MARK-3[®]

CDI PROTECTIVE ENCLOSURE

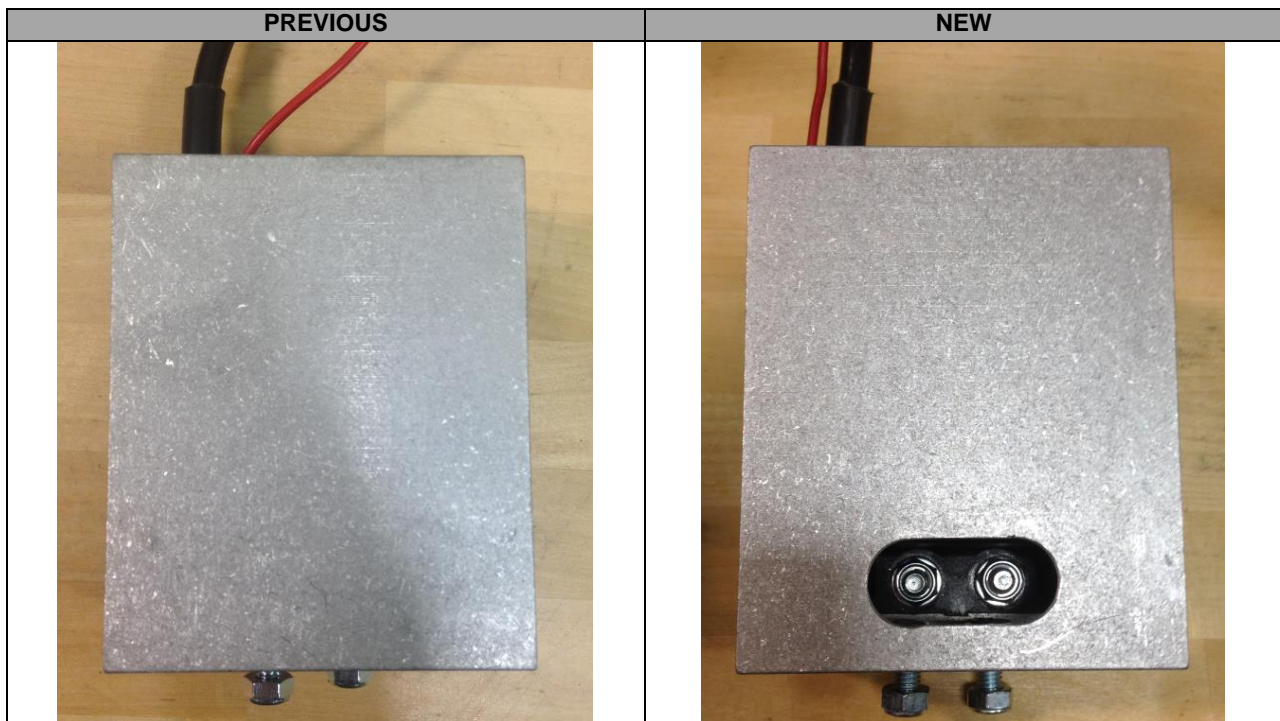
A slotted hole was added to the CDI enclosure to facilitate access to the fasteners.

A cut-out on the front was added to the aluminum enclosure (mounting block) to facilitate the assembly and removal of the CDI module. Access to the fasteners is improved.

Item numbers will remain identical. This running change will be implemented in the Fall 2017.
